APPENDIX 2D.  
WATER DISTRIBUTION SYSTEM  
COMPUTER MODEL & HYDRAULIC  
ANALYSIS

**Reference: Water Distribution System Computer Model & Hydraulic Analysis**

As requested, we have performed an evaluation of the water distribution system for the proposed Winding Creek and Cornwall Commons developments. Each development was analyzed under the different distribution system improvements requested by Lanc & Tully Engineers in their letter dated May 17, 2007.

DISTRIBUTION SYSTEM  
IMPROVEMENT ALTERNATIVES

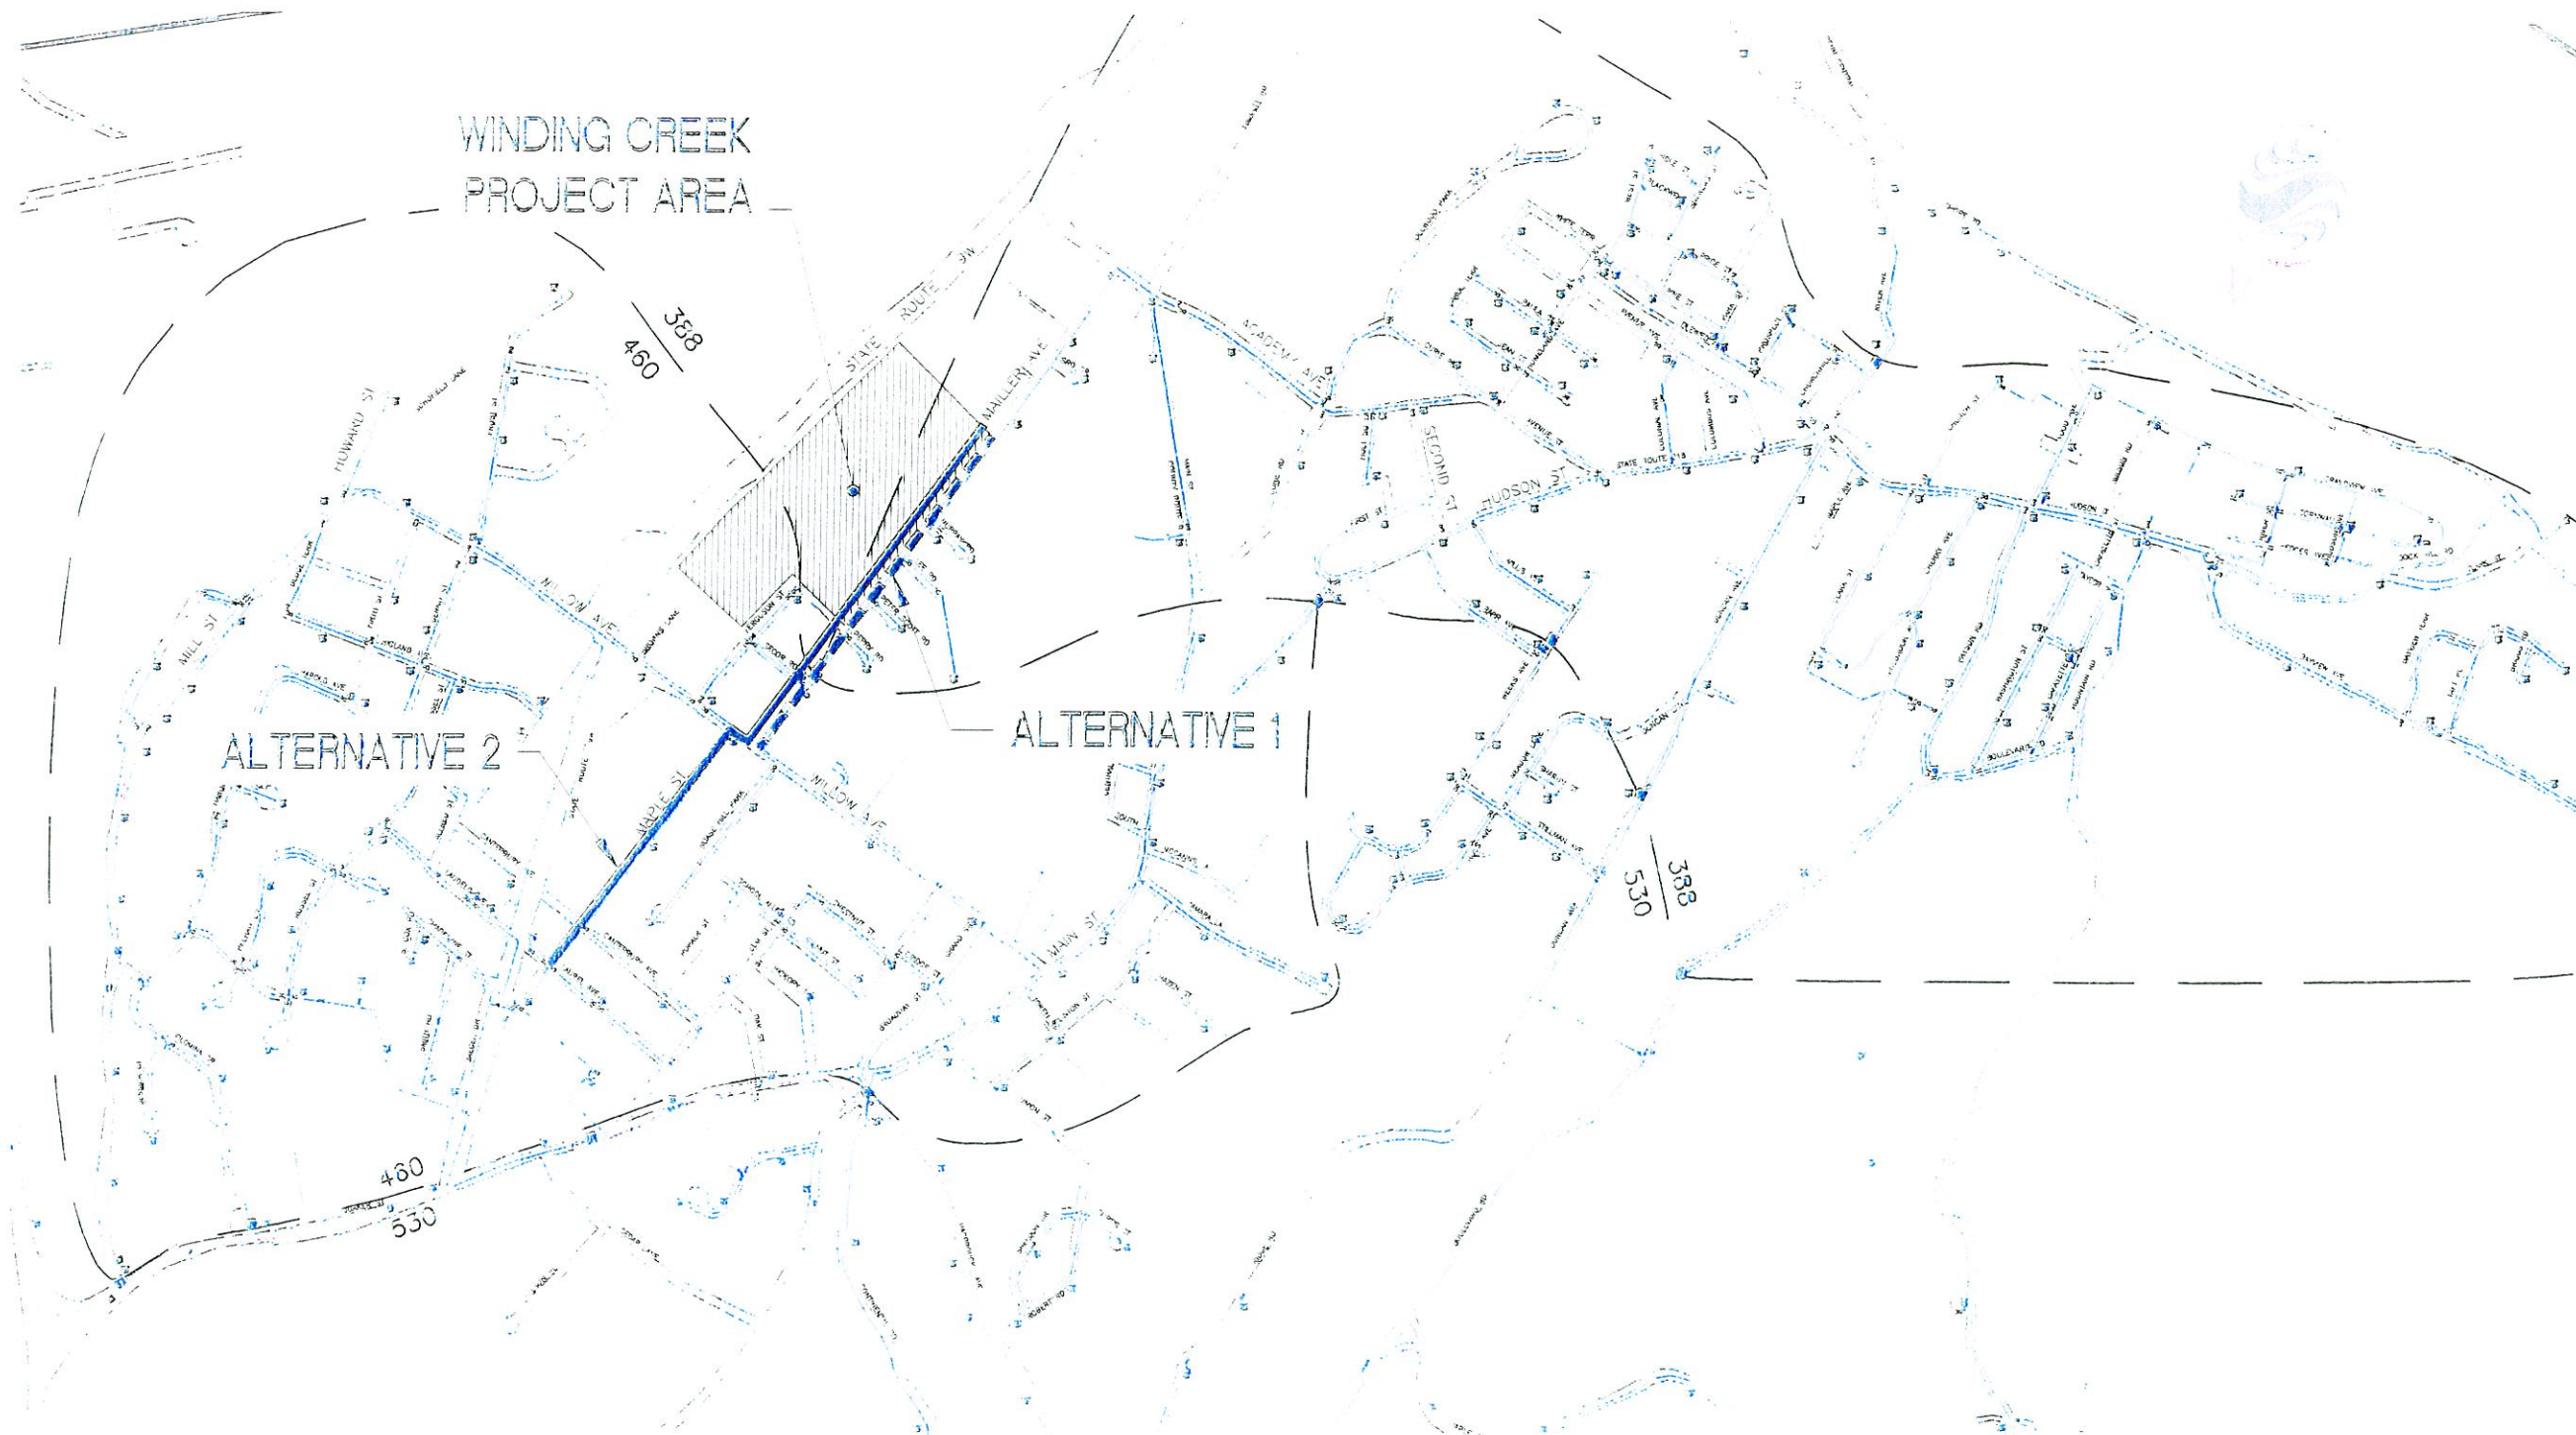
There are currently 2 alternatives proposed for providing water service to the Winding Creek project. These options are shown on Figure 1, and described as follows:

**Alternative 1:** Install a new 12-inch water main (2,100± LF) on Mailler Avenue, from Willow Avenue to the project entrance.

**Alternative 2:** Install a new 12-inch main (4,000± LF) along Maple Avenue, from the intersection of Laurel Avenue to Willow Avenue, then along Willow Avenue to Mailler Avenue and along Mailler Avenue to the proposed Cornwall Commons development.

The proposed Winding Creek development will create a new demand on the water system of approximately 13,520 gallons per day (average day) and 20,280 gallons per day (maximum day). The results of the hydraulic analysis indicate that under the proposed connection to the existing distribution system, the operating pressures within the lower elevations of the development will be above recommended pressures. Additionally, with the relocation of the Mailler Avenue PRV, several side streets off of Mailler Avenue would undergo significant increases in static pressure in excess of AWWA recommended pressures.

We have determined that the preferred hydraulic grade line for the Winding Creek development is 378 feet and recommend the development connect to the existing 388 service zone (approximate hydraulic grade line = 388 feet). This would involve leaving the existing Mailler Avenue PRV in its current location and providing a Service Zone boundary (PRV, closed valve, etc.) at the development connection on Ferguson Street. A simulation at the highest elevation in the development (Elev = 218) was performed with the Mailler Avenue PRV at its current location. The results were as follows:

- Connect development to 388 Service Zone
- Leave Mailler Avenue PRV in current location.
- Install new 12-inch water main on Mailler Avenue.
- Modify Mailler Avenue PRV Station by installing parallel 8-inch and 4-inch PRVs.
- Provide Service Zone boundary at development connection on Ferguson Street

DISTRIBUTION SYSTEM  
IMPROVEMENT ALTERNATIVES

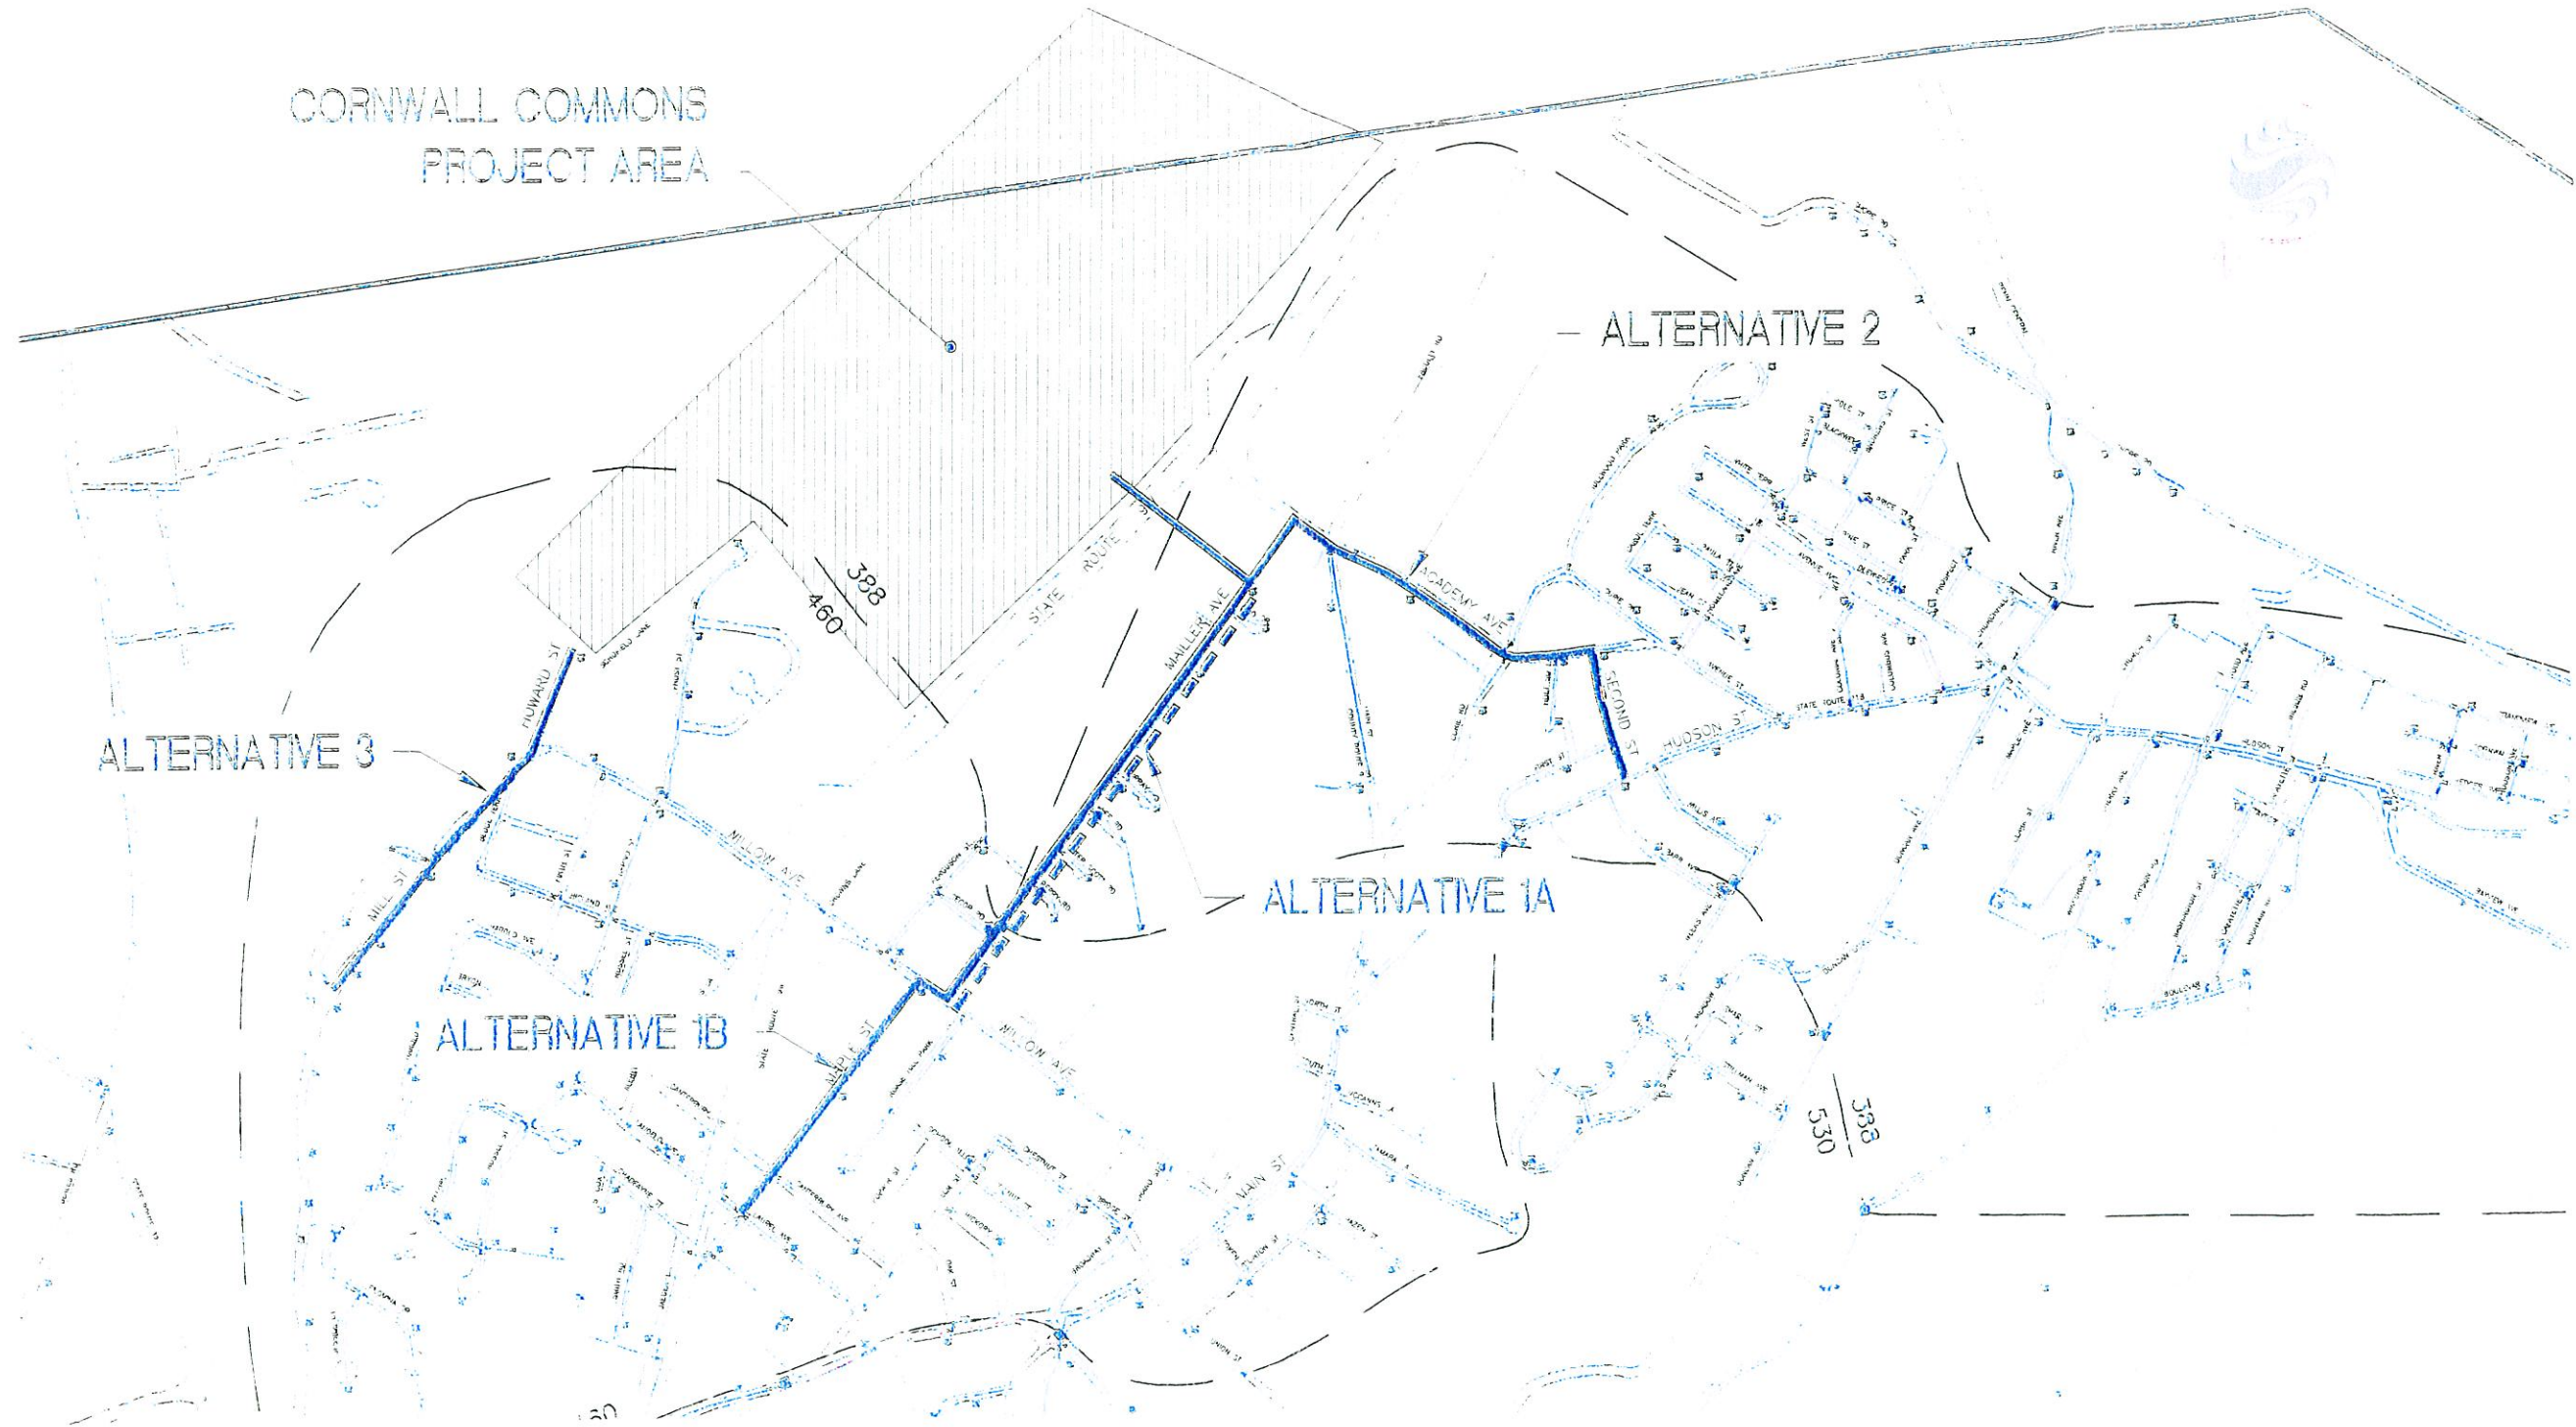
The proposed project ranges in topography from approximate elevations of 138 ft. to 238 ft. There is currently municipal water service south of the proposed development on Frost Lane (6-inch main) and Howard Street (6-inch main). There is also municipal water service on Mailler Avenue (6-inch main) to southeast of U.S. Route 9W. There are currently 3 alternatives proposed for providing water service to the Cornwall Commons project. These options are shown on Figure 2, and described as follows:

**Alternative 1:** Install a new 12-inch main (5,000± LF) along Maple Avenue, from the intersection of Laurel Avenue to Willow Avenue, then along Willow Avenue to Mailler Avenue and along Mailler Avenue to the proposed Cornwall Commons development. Under this connection to the existing system, the Cornwall Commons development would be included in the 388 Service Zone. For modeling purposes, this was studied as two discrete elements, as follows:

- **Alternative 1A** – new 12" main in Maple Avenue
- **Alternative 1B** – new 12" main in Mailler Avenue

**Alternative 2:** Install an new 12-inch main (3,300± LF) starting at the intersection of Hudson Street and Second Street, running down Second Street and Academy Avenue, along Mailler Avenue, up Halverson Street and then across U.S. Route 9W into the project site. Under this connection to the existing system, the Cornwall Commons development would be included in the 388 Service Zone.

**Alternative 3:** Install a new 12-inch main (3,200± LF) on Mill Street starting at the existing 12-inch main near Old Mill Street, then up Howard Street into the Cornwall Commons project. Under this connection to the existing system, the Winding Creek development would be included in the 460 Service Zone.

The results of the hydraulic analysis indicate that, from the standpoint of satisfying minimum system hydraulics in order to serve the project, the Cornwall Commons development could utilize connection Alternative 2, tying into the 388 service zone, in addition to Alternative 1A (installation of a new 12-inch main installation on Mailler Avenue, as was also recommended for the proposed Winding Creek development). However, from a system reliability standpoint, a second connection to the Village's water system is necessary, given the overall project's size, and so it is recommended that Alternative 3 be provided in lieu of Alternative 2. Further, as Alternative 3 proposes a connection to the 488 service zone, a new Pressure Reducing Valve (PRV) Station will be required so as to avoid creation of pressures within the proposed development above AWWA recommended pressures.

- Requires the following improvements also needed for the Willow Creek project (connecting to the 388 Service Zone):
  - a. Install new 12-inch water main on Mailler Avenue. (Also recommended for Winding Creek)
  - b. Extend the 12-inch main from Mailler Avenue up Halverson Street and then across U.S. Route 9W into the project site.
  - c. Modify Mailler Avenue PRV Station by installing parallel 8-inch and 4-inch PRVs.
- Install a new 12-inch main on Mill Street starting at the existing 12-inch main near Old Mill Street, then up Howard Street into the Cornwall Commons project (Alternative 3).
- Installation of a new PRV along Howard Street, to create a 388 service zone boundary to avoid excessive pressures within the development
